TOWN OF MILTON
PLANNING AND DEVELOPMENT
BUILDING PERMIT: 17-7101
BUILDING: REVIEWED
SCOTT SHERRIFFS JUN 12, 2017
PLANS EXAMINER DATE
Neither the issuance of a permit nor carrying out of
inspections by the Town of Milton relieves the owner from
full responsibility for compliance with the provisions of
the Ontario Building Code Act and the Ontario Building
Code, both as amended, as well as other applicable
statutes and regulations of the Province of Ontario,
By-laws of the Region of Halton and Town of Milton

JUNIPER 7-149
ENERGY STAR

PROJECT NAME
LECCO RIDGE

4.					BASEMENT PLAN					1	
3.					ELEV. 1						
2.	UPDATED FOR LOT 149				APR 2017	SCALE	BY	AREA			PAGE No.
1.	ISSUED FOR REVIEW				SEP 2016	3/16"=1'-0"	V.G.	3093			
REVISIONS			DATE		PROJECT						
			JUL 2016		02-10-106

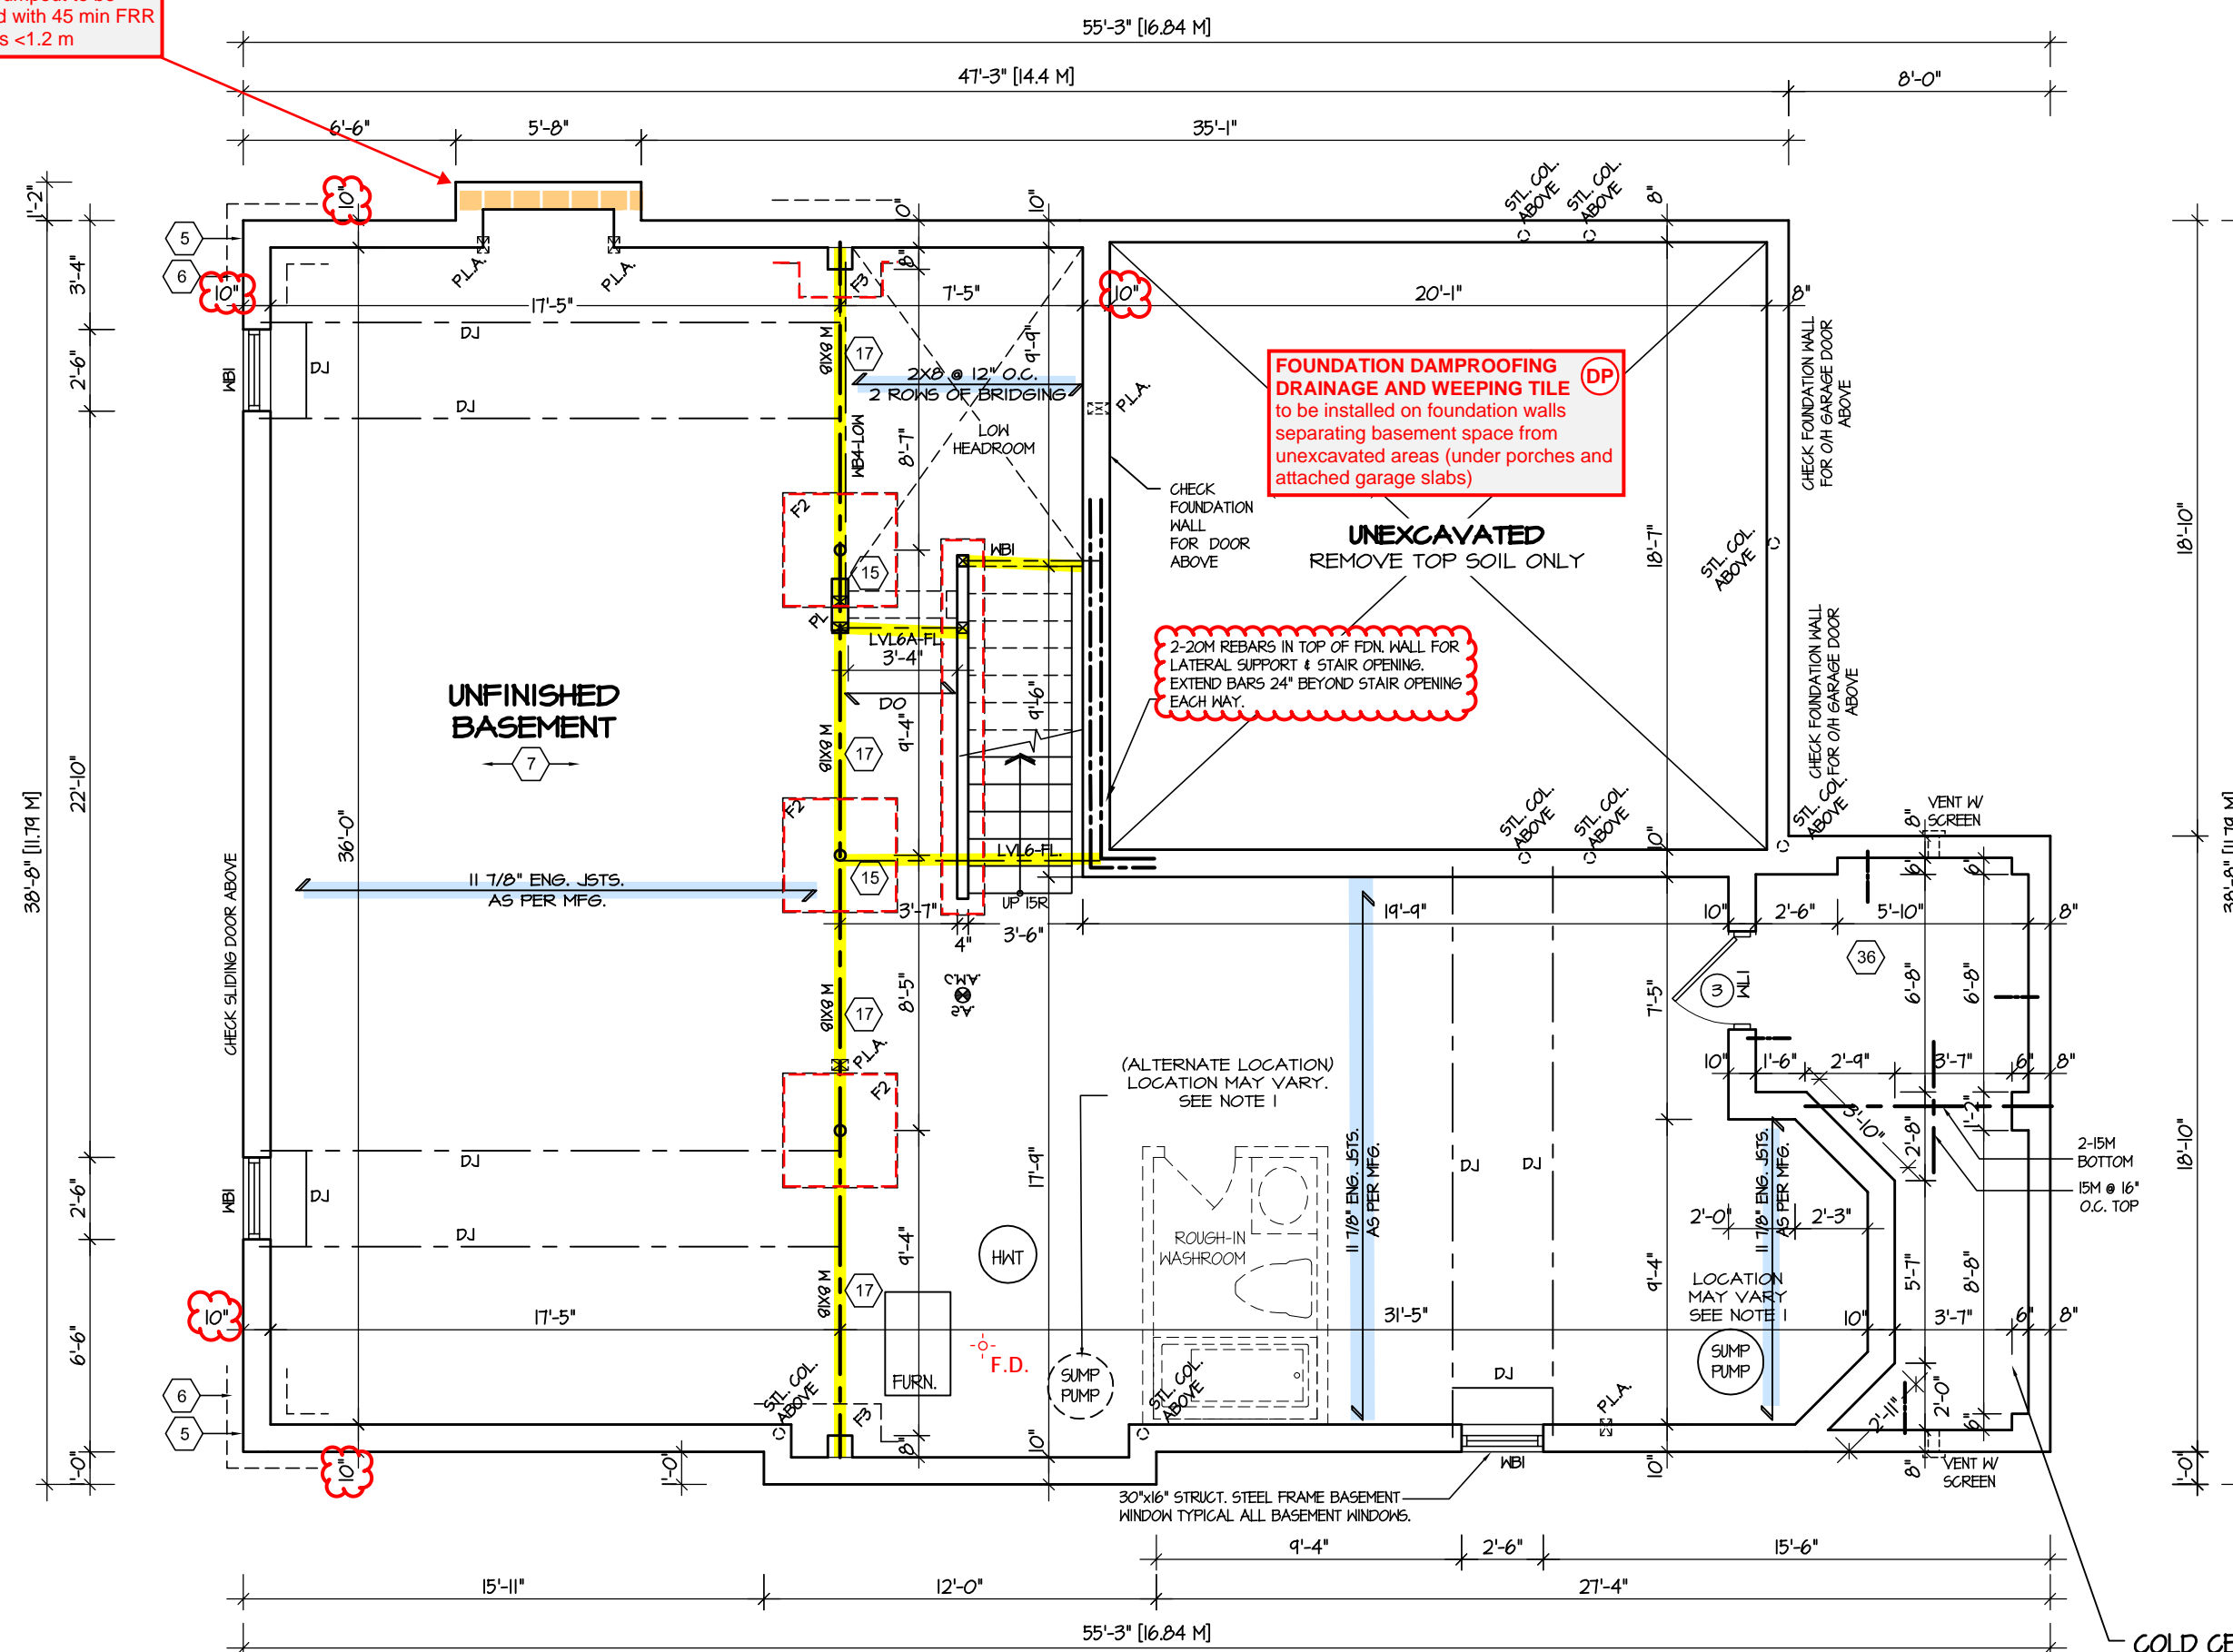
LD <1.2 M FOR BUMPOUT
Fireplace bumpout to be constructed with 45 min FRR as the LD is <1.2 m

SECOND FLOOR PLAN "I"-LOT 149
SIDE UPGRADE
10' HIGH FIRST FLOOR

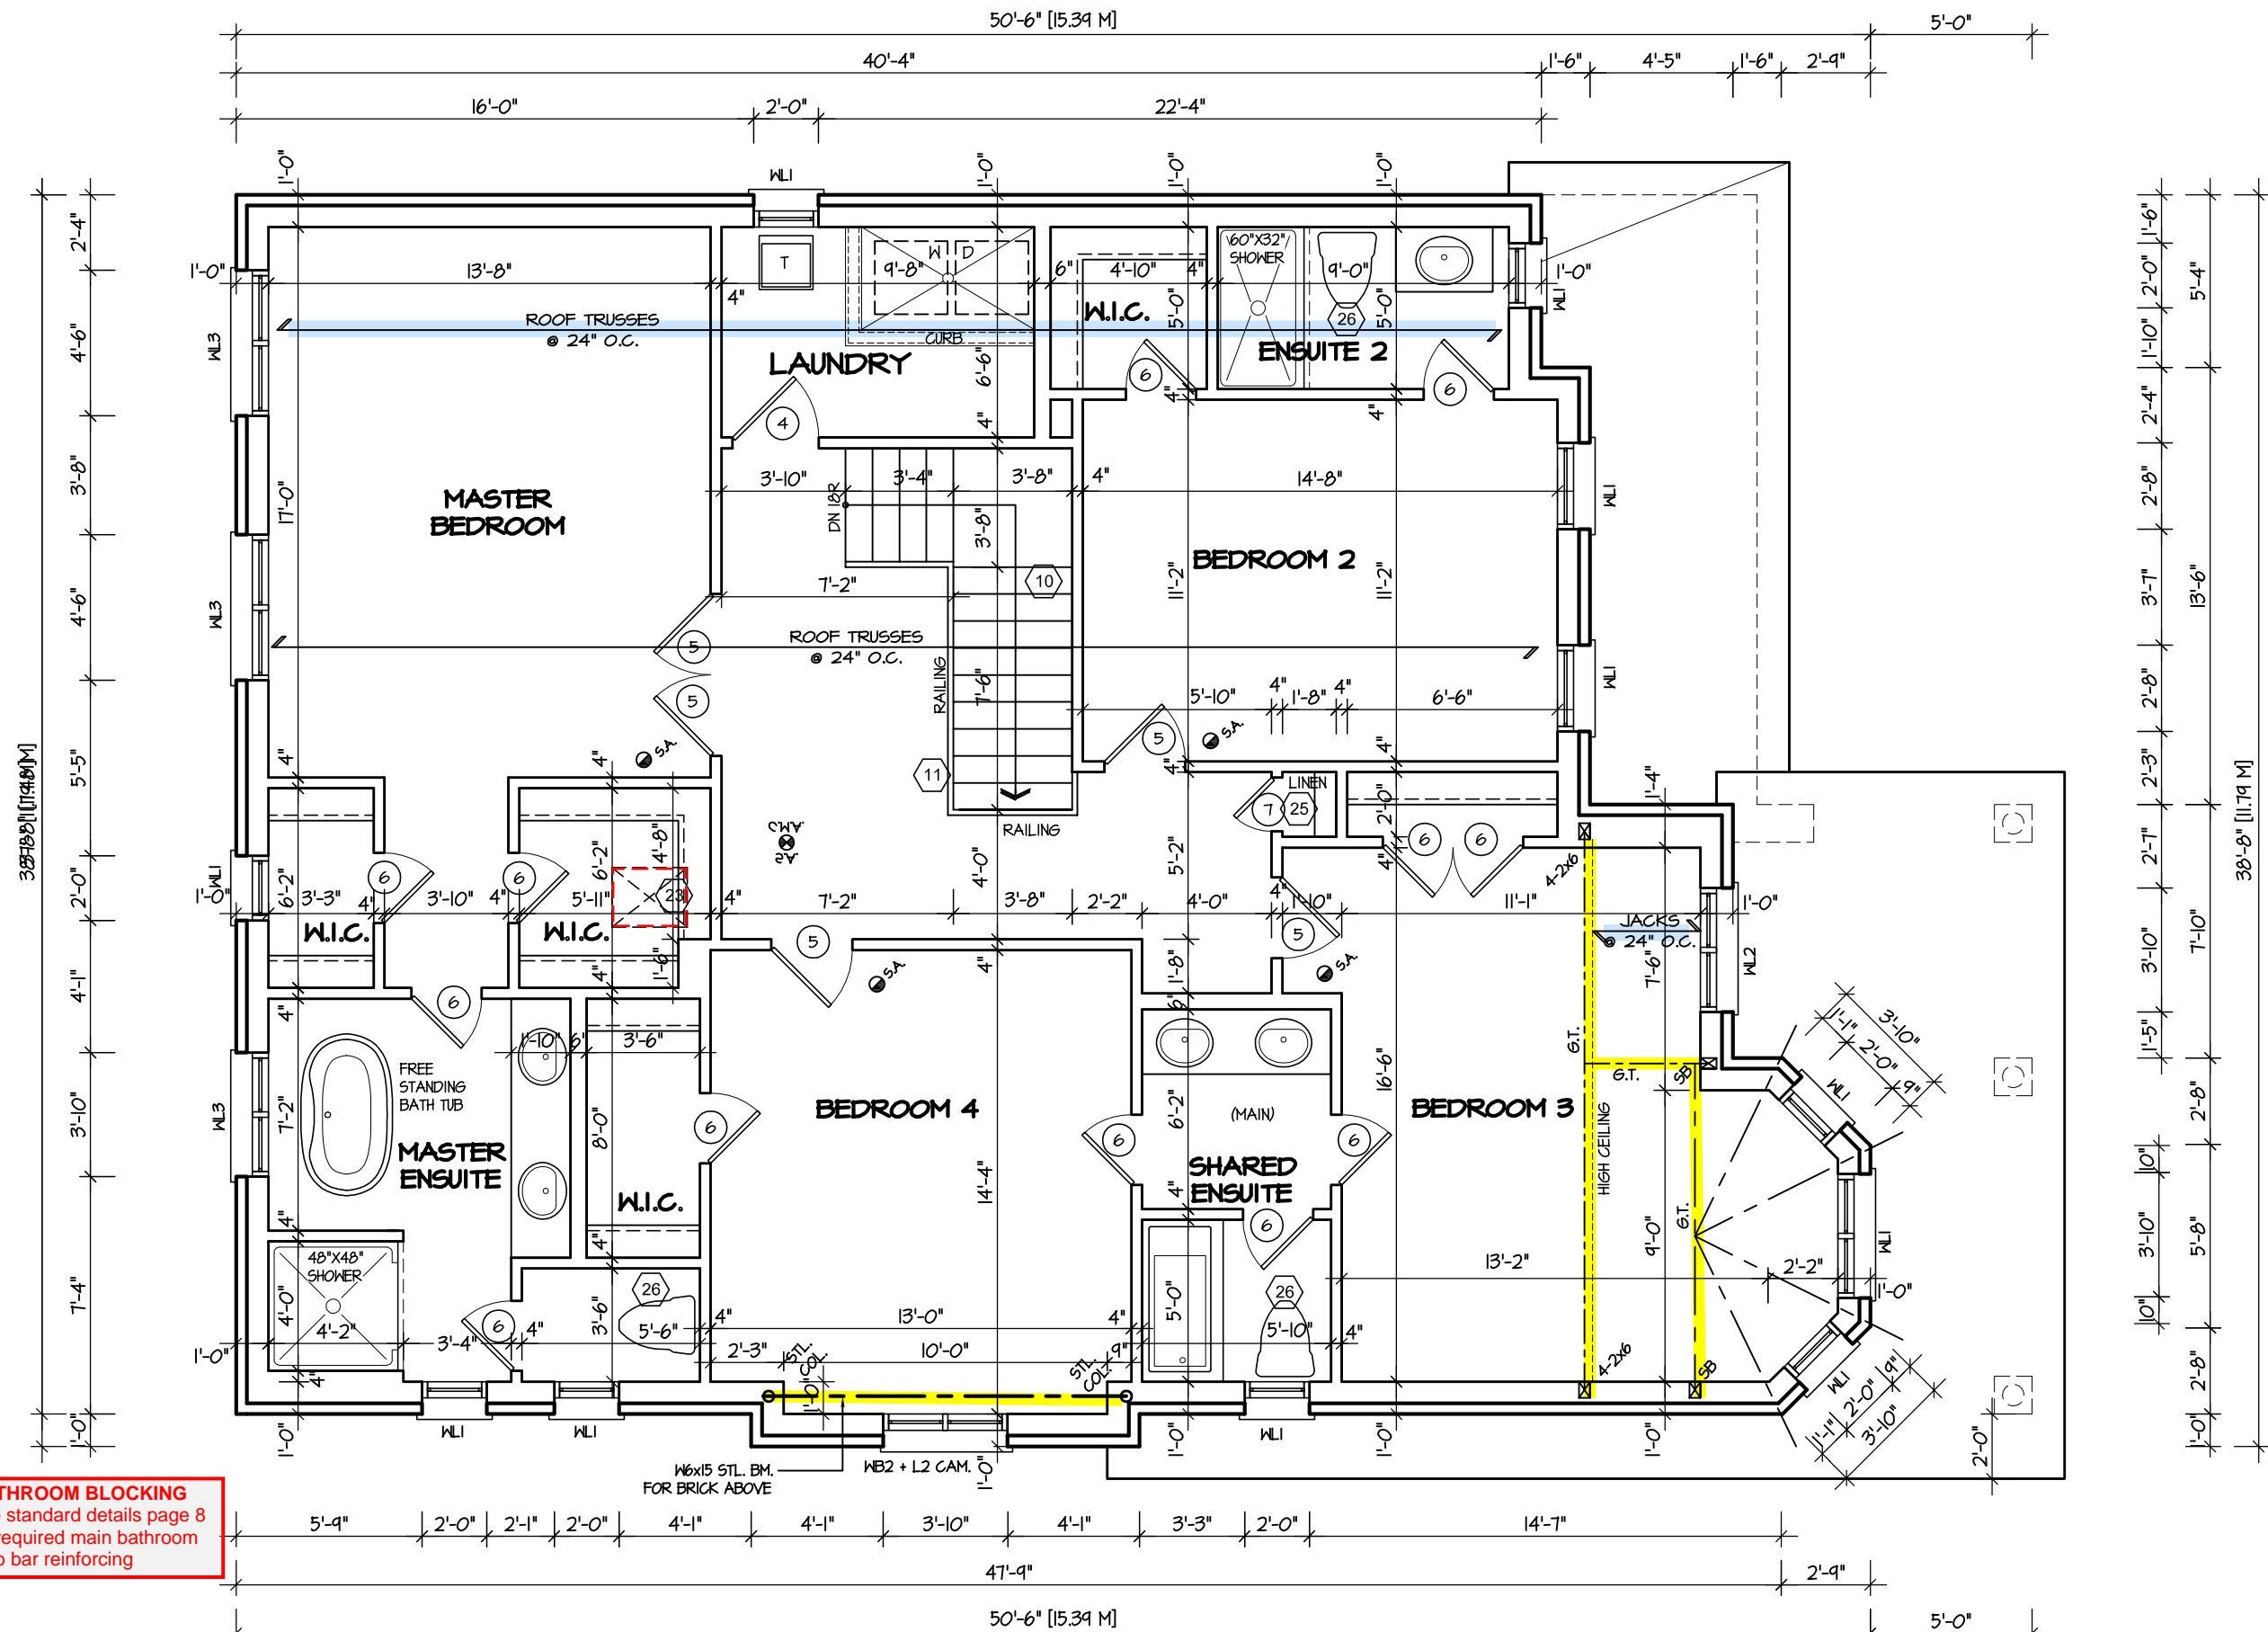
BATHROOM BLOCKING
See standard details page 8
for required main bathroom
grab bar reinforcing

SHEET TITLE	
RIGHT SIDE ELEVATION 1	
SCALE 3/16"=1'-0"	BY V.G.
DATE JUL 2016	TYPE

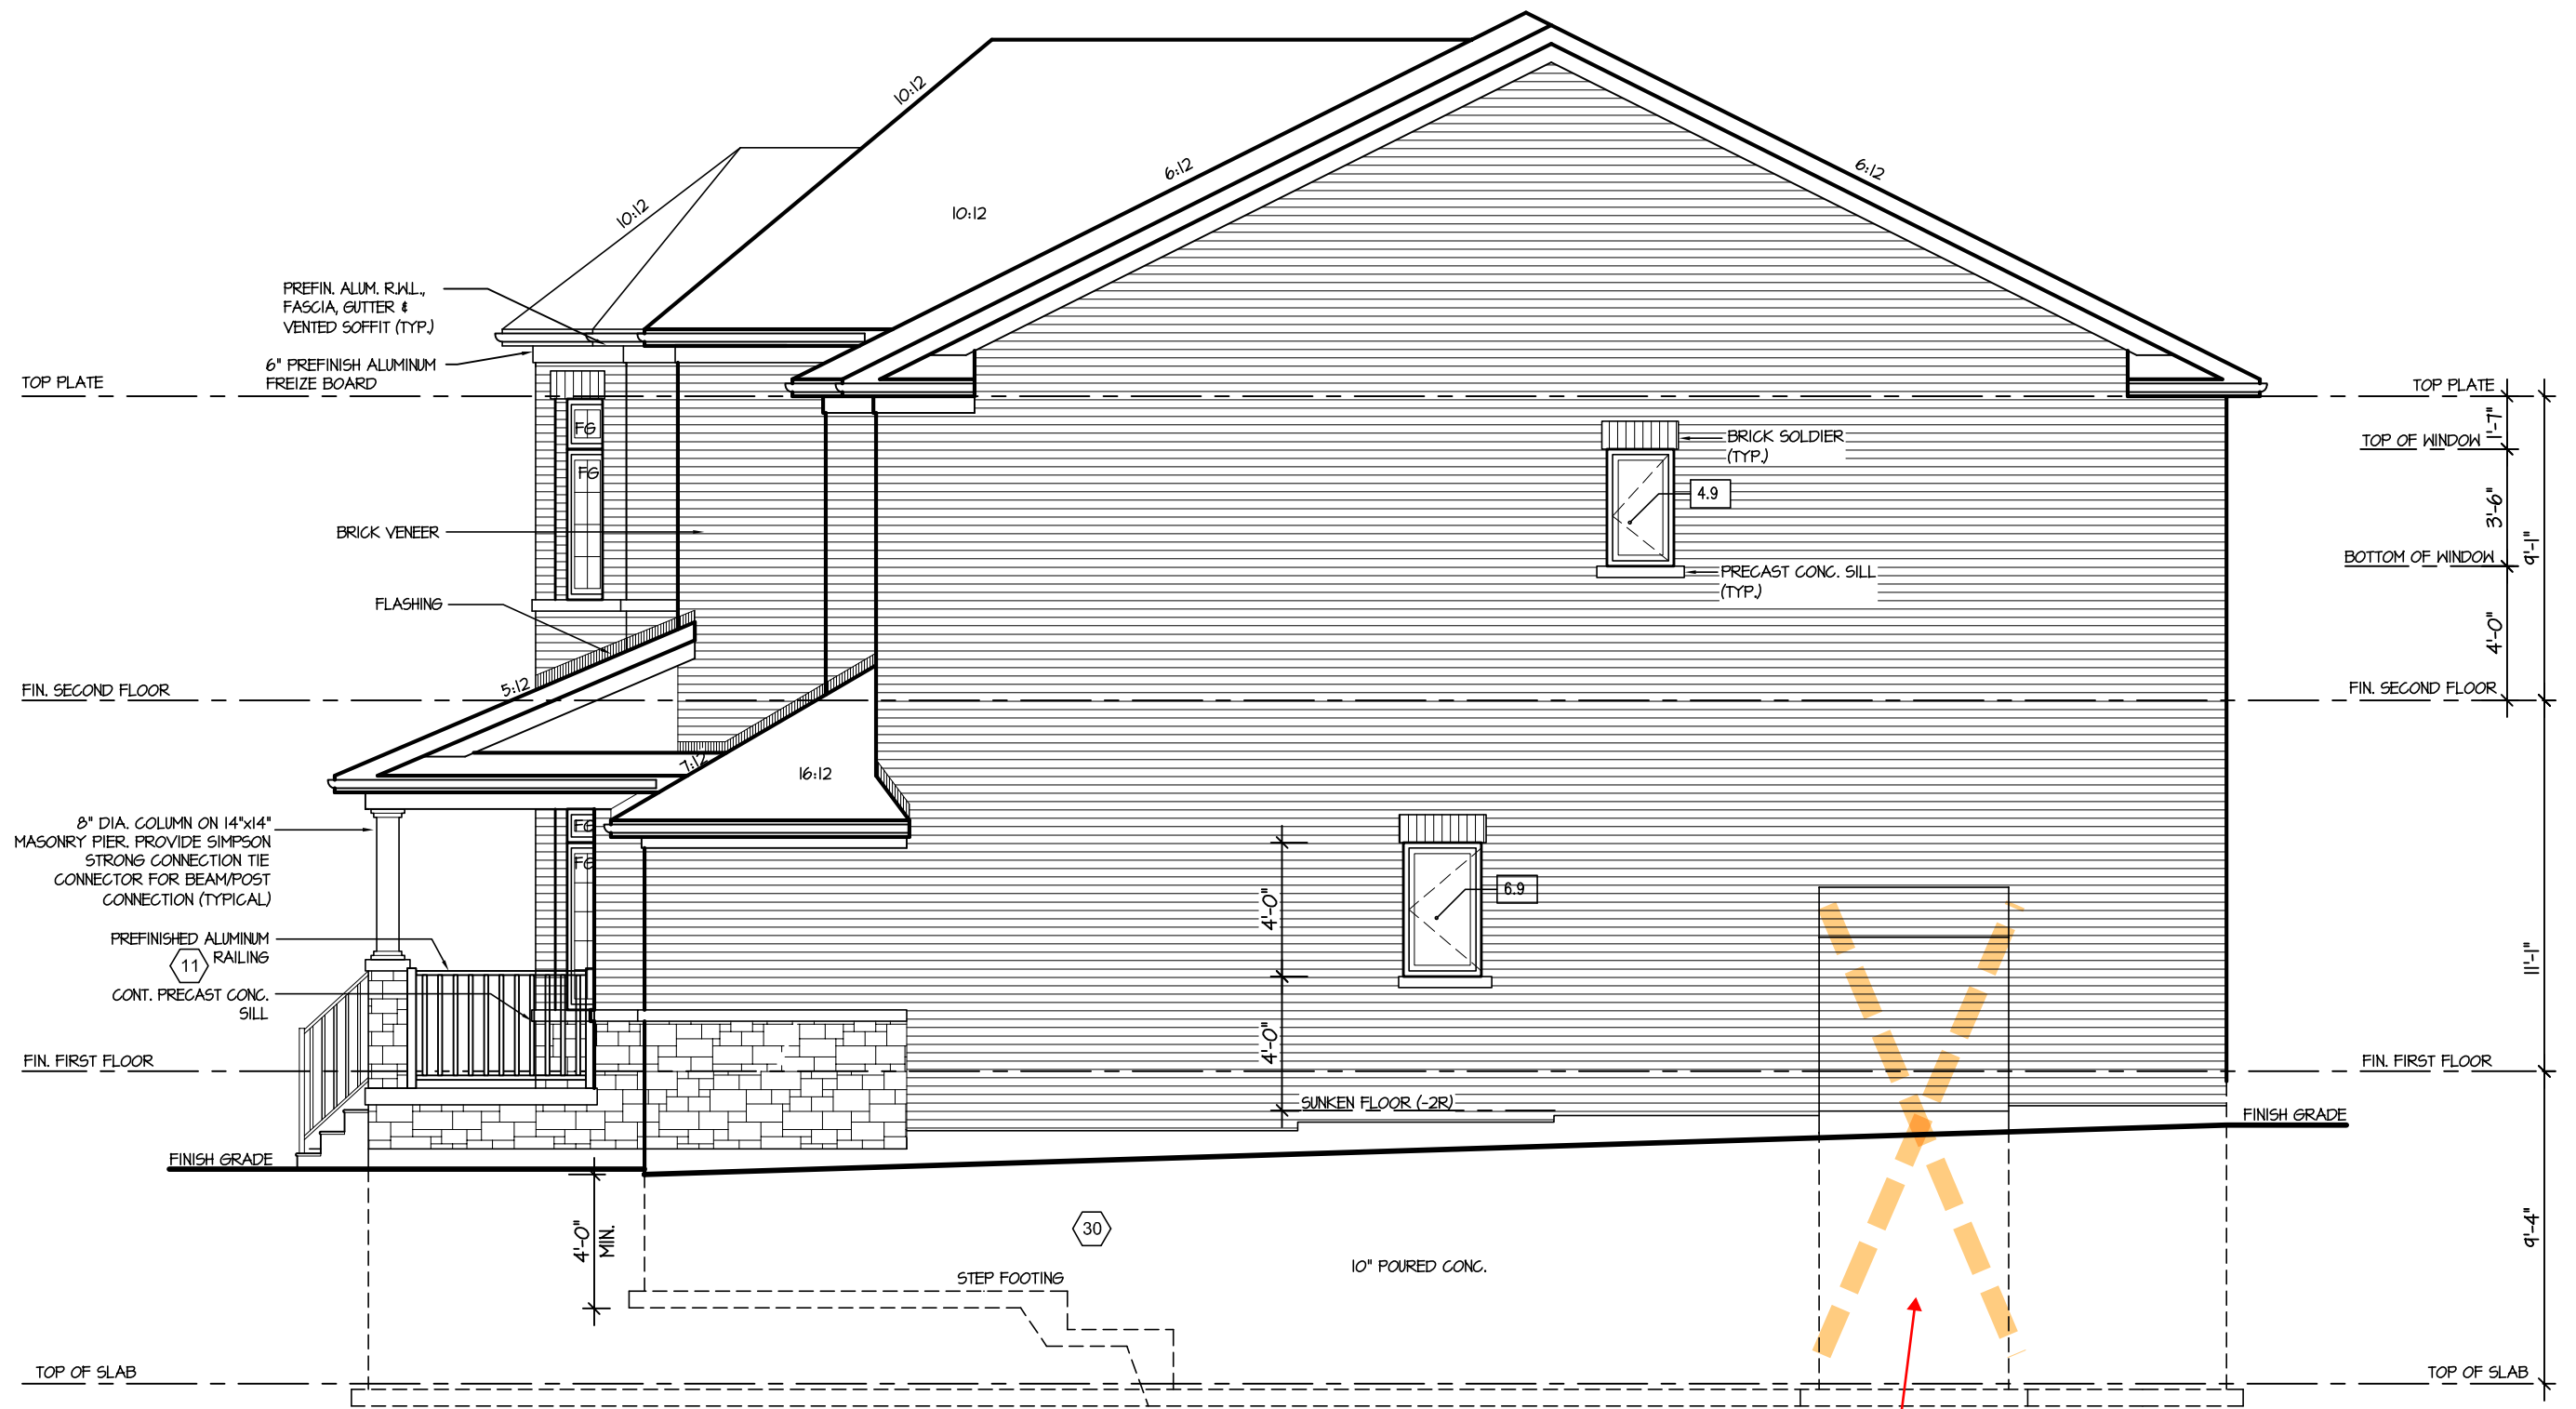
45 MIN FRR

LD <1.2 M FOR BUMPOUT
Fireplace bumpout to be
constructed with 45 min FRR
as the LD is <1.2 m
